I wanted to thank everyone for the spirited discussion last week. And special thanks to Duane, Jason, Greg, Jonathan, and Kevin for engaging in follow up discussions. I wanted to provide some additional information and an amended version of the 047 proposal to address some of the comments brought up. Kjell and Krista, please accept the attached Code Change Form as a friendly amendment based on the comments below and the general discussion during the previous TAG meeting.

2018 IPC**TABLE E202.1
INTERNAL VOLUME OF VARIOUS WATER DISTRIBUTION TUBING**

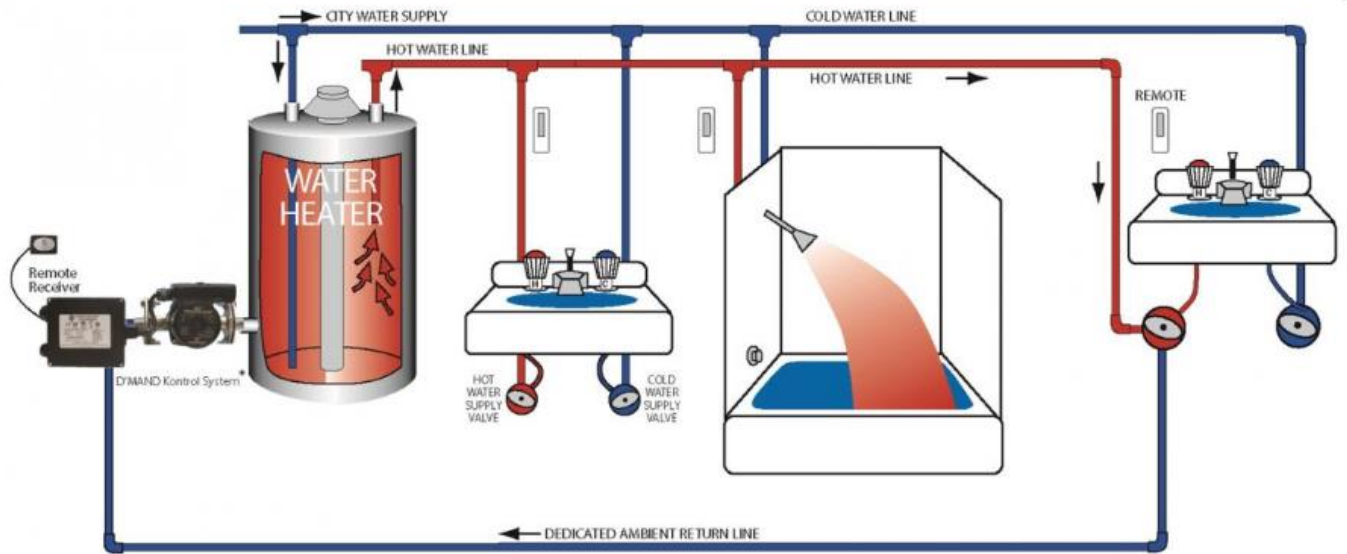
Comment #1 – The code as written would violate IPC or UPCs. In particular, this was brought up in regards to 046 as new code language, to be referenced by Table R406.3 or any performance approach to codes, in order to ensure that measuring volume of water in the plumbing supply system will hold no more than a pint of water from the source of heat*

*Source of heat is either a water heater or the nearest portion of the plumbing distribution system as primed by a demand recirculation pump in the amended proposal.
